**NOTICE OF APPEAL TO PLANNING COMMISSION OF SHARON LOVEYS TO NOTICE
OF DECISION DATED OCTOBER 24, 2017 TO GREEN HILLS REQUEST FOR
GRADING PERMIT
CASE NO. ZON2017-00324**

The Grading Permit should not be approved for the following reasons: **COMMUNITY DEVELOPMENT
DEPARTMENT**

Area 5 – Depiction of “Area 5” from Green Hills Website showing vacant land to be used for “earth interments” by Green Hills. Under the Master Plan, Area 5 is stated to be “Lake View Garden” (See Below).

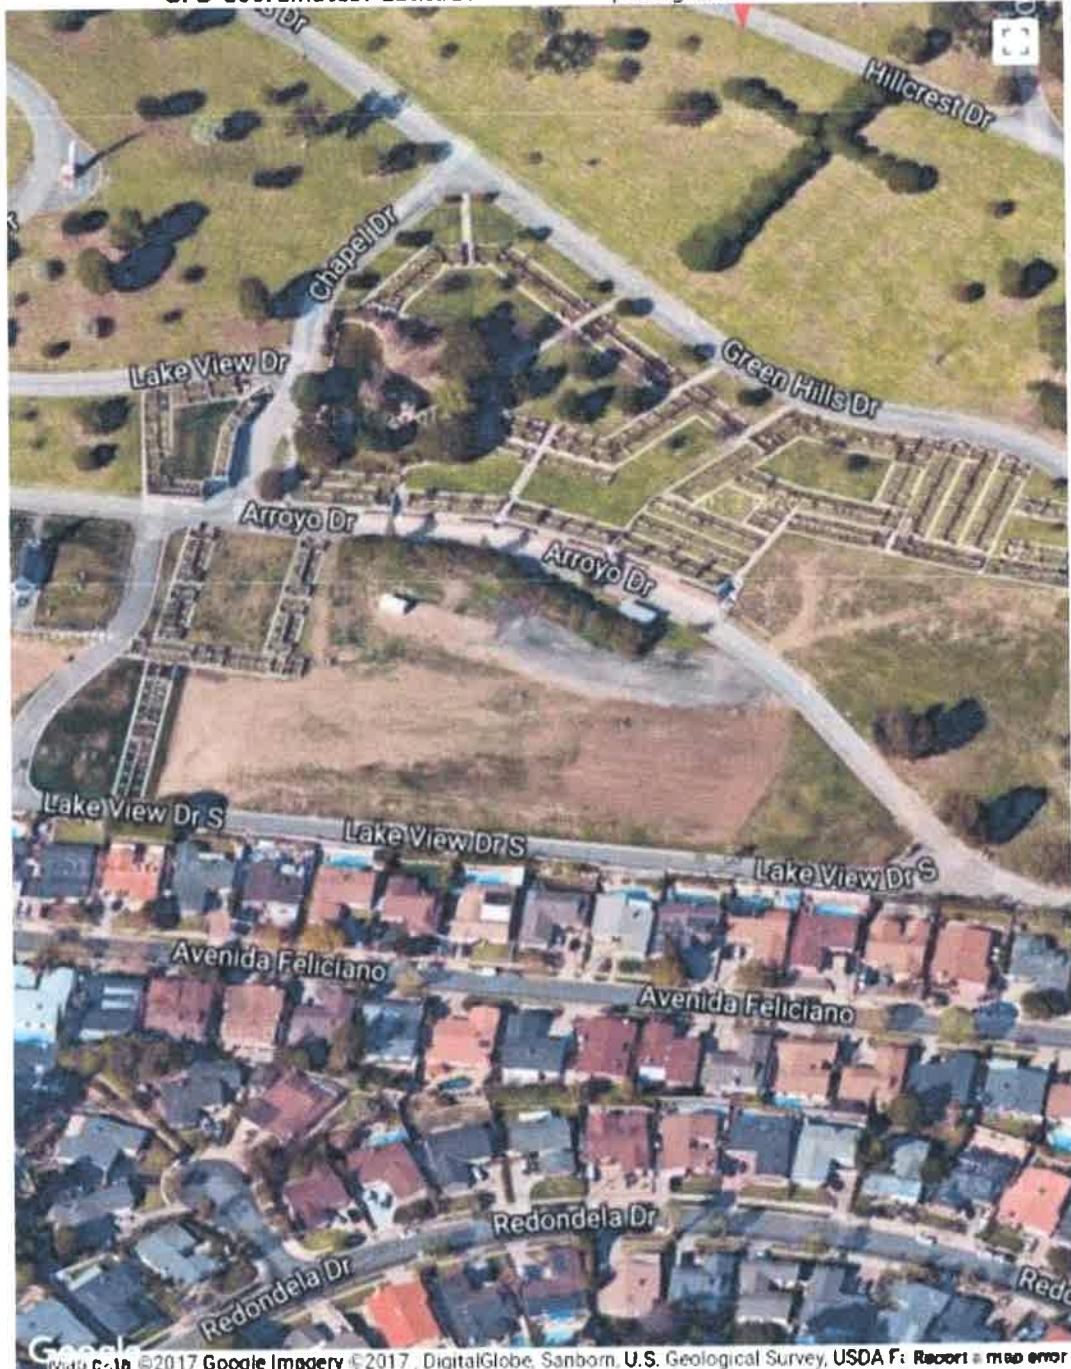
6. The Director cannot approve this Grading Permit unless and until the Director has further amended the visual depiction of the Green Hills Master Plan to bring it into conformity with the noted set-back distances (20 feet to the south and clarifies the road and landscape buffer and whether said road and landscape buffer are included within the boundaries of the set-back).

Approved are 3,440 Double-Depth Lawn Crypts and 58 Family Estates. Lawn Crypts are considered "ground burials" (legally known as "earth interments" (Health & Safety Code Section 7009 (Definition of "Interment"); Health & Safety Code Section 7013 (definition of "Burial"); Health & Safety Code Section 7014 (Definition of "Grave").

City's Response: The proposed interments contemplated under this grading proposal are outside the 20' set-back and thus consistent with the Green Hills Master Plan. If so, this should be clearly set forth in the City's and Green Hills' presentation to the Planning Commission.
